### SLI MEDICAL OFFICE BUILDING JSP 18-74

Consideration at the request of SLI Medical Preliminary Site Plan and Storm Water Management Plan approval. The subject property is zoned B-3 and is located on the north side of Grand River Avenue and east of Novi Road in Section 23. The applicant is proposing to remodel and occupy the existing 45,200 square feet building for medical and general office use along with warehouse space housing medical equipment. The applicant is proposing to build additional parking and related landscape improvements to accommodate the change of use.

# PLAN REVIEW CENTER REPORT

**Planning Review**  
**SLI MEDICAL OFFICE**

**PRELIMINARY SITE PLAN**  
**SLI MEDICAL**  
PART OF THE NE 1/4 OF SECTION 23, T1N, R8E, CITY OF NOVI, OAKLAND COUNTY, MICHIGAN

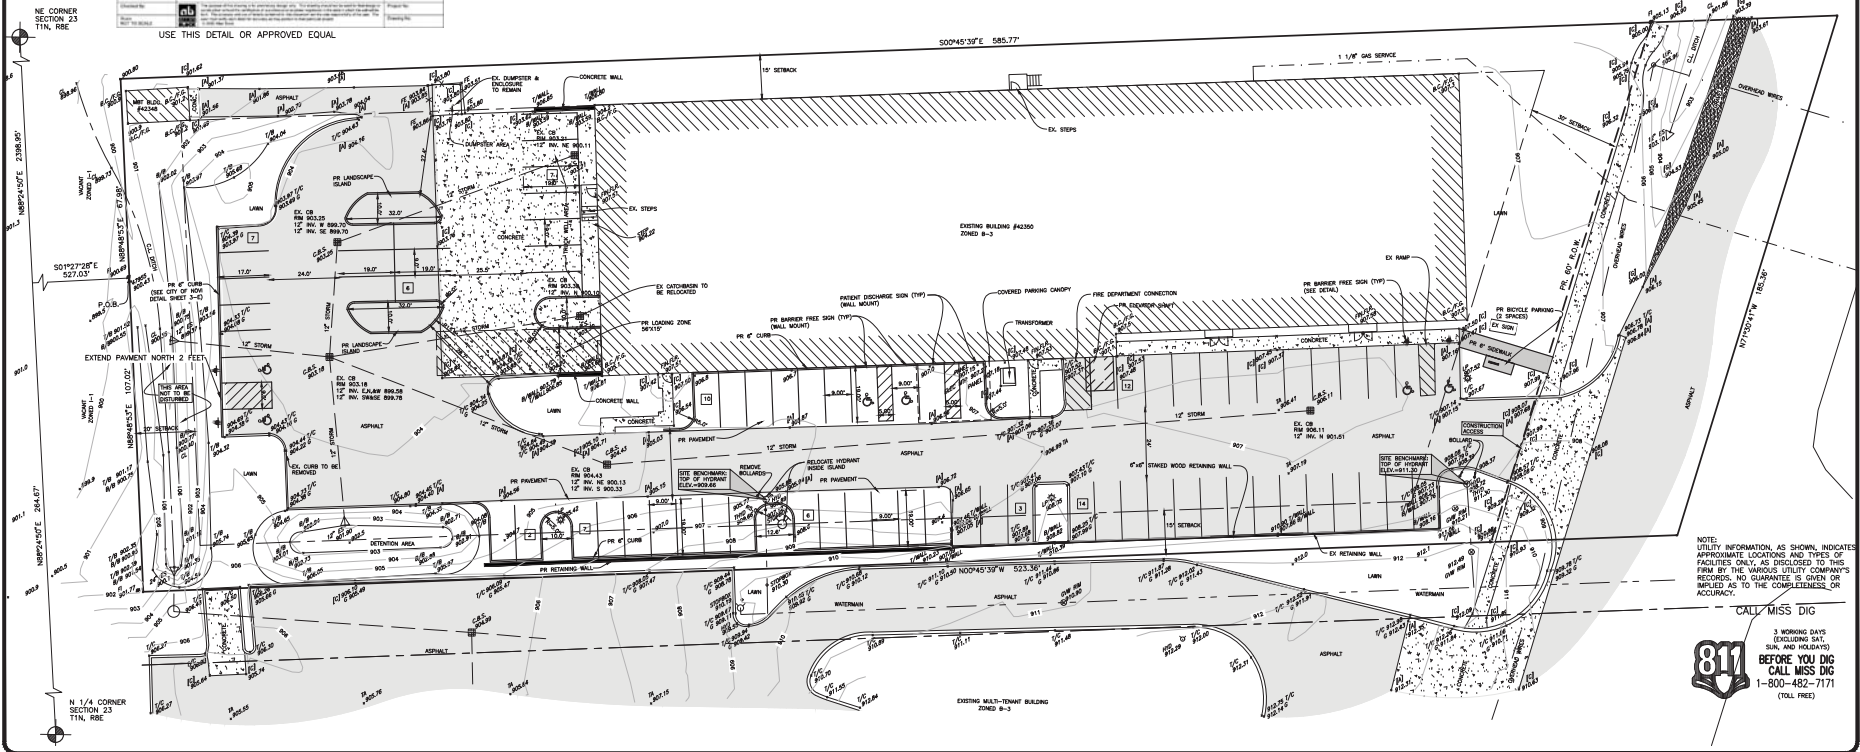
2. **Barrier Free Parking Spaces:** A minimum of four parking spaces are required based on ADA guidelines. The plan shows about eight spaces. One of the areas in the building is labeled as 'Physical Therapy' on the floor plan. The applicant should indicate if additional handicap spaces would be warranted based on the use and try to accommodate those spaces at this time. **Building indicates that a minimum of 20% of regular parking required for physical therapy use should be barrier free. This would affect the minimum parking available on the site. If it is determined that additional parking will be required as part of the Building Plan review, please note that a revised plan will required along with any related approval. Please clarify in the response letter.**

3. **Bike Parking:** Bike parking is required for the proposed use. Please provide the minimum required bike parking. Refer to plan review chart for more details.

4. **Truck Maneuvering Diagrams:** Please provide truck maneuvering paths to indicate how a dumpster truck and loading trucks would access the dumpster and the loading dock respectively and exit the site.

The site plan indicates a total of 74 parking spaces on site, once the proposed improvements are made. The reduction in the minimum required parking (from 122 to 75, a total of 47 spaces) would require approval of a variance from Zoning Board of Appeals, which could be justified based on the information in the submittal, and the applicant's parking assessment prepared by Rich and Associates, and as reviewed by the City's Traffic Engineering Consultant. Please note, the study is based on the current proposed mix of uses only. Parking needs should be reassessed if a change of use happens.

This request is scheduled for consideration by Zoning Board of Appeals at their June 11 meeting. **The ZBA variance request is for 75 minimum parking. The current revised plan indicates 74 spaces. The applicant should provide a revised site plan in PDF format that indicates 75 spaces prior to Planning Commission meeting.**

PRELIMINARY LANDSCAPE PLAN  
**SLI MEDICAL**  
PART OF THE NE 1/4 OF SECTION 23, 11N, 88E,  
CITY OF NOV, OAKLAND COUNTY, MICHIGAN

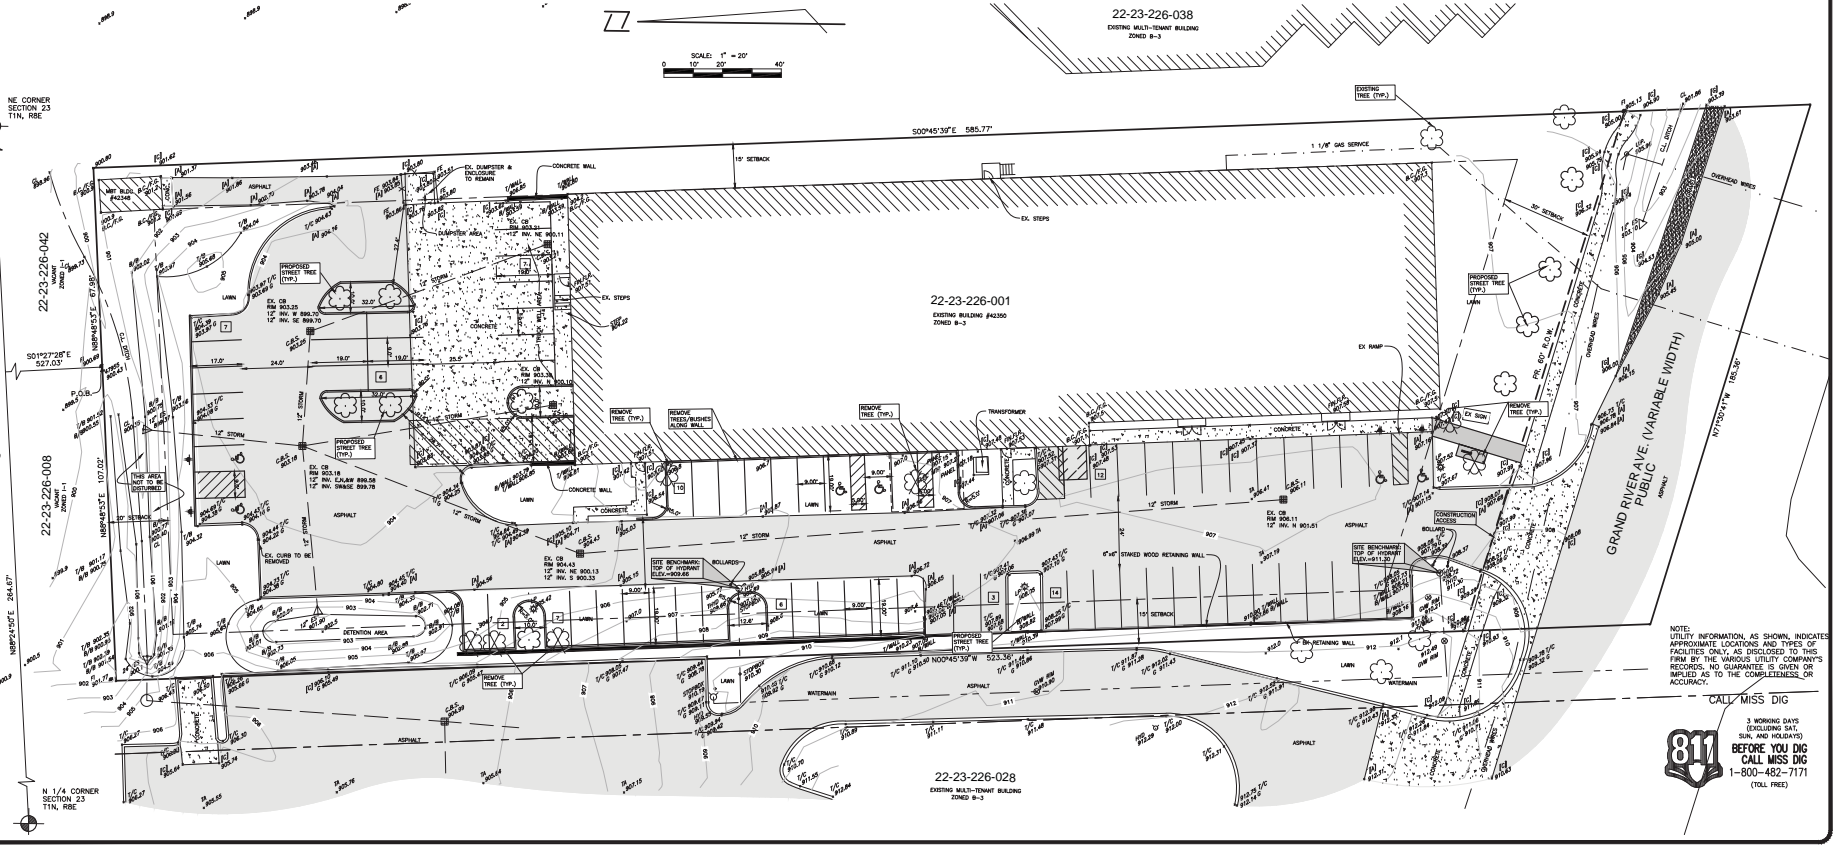
This project is **still not recommended for approval**. **The landscape plan is deficient in information provided, as well as landscaping provided per the current ordinance**. A number of landscape waivers are required, some of which are supported, but others which aren't.

1. Existing tree symbols are shown, and trees to be removed are designated as such with an X.
2. **Please provide a tree chart showing the trees' identity, size (dbh) and whether the tree will remain or be removed.**
3. If any tree is found to be regulated, replacement calculations are required. Based on a site visit, it doesn't appear that any of the trees within the limits of disturbance are regulated (36" dbh if not in a regulated woodland, 8" dbh if within a regulated woodland) but the tree chart will confirm that.

1. Please show the Road Commission for Oakland County clear vision zone at the Grand River Entry.
2. **Please provide calculations as outlined in the Landscape Chart and provide the required canopy/large evergreen and canopy trees.**
3. If the new rules will be followed, please provide all of the required trees.
4. Little of the original greenbelt landscaping remains. **If the original landscape will be restored, please provide all of the plantings per that plan that were in the greenbelt. Species substitutions may be made (and in some cases need to be).**
5. As there is not sufficient room in the right-of-way for the required street trees, a landscape waiver for those trees may be requested. *It would be supported by staff.*

1. **Please provide calculations as outlined in the Landscape Chart and provide the required trees and landscape area.**
2. **Please show the areas in SF of each interior island.**

1. The proposed plan shows all interior landscape areas and existing trees being removed, with no replacements provided.
2. As the original plan did not include perimeter plantings, no new perimeter trees are required now if the original plan is being restored.
3. **In any case, calculations for the perimeter trees must be provided, and a landscape waiver is required for any deficiency in trees provided.** *The waiver would be supported by staff if perimeter trees are placed where there is room for them, given that the outer perimeter is not increasing.*

**Please either restore the trees originally proposed along the west side of the basin or add large native shrubs (3 species) along the 70-75% of the pond's high water line.**
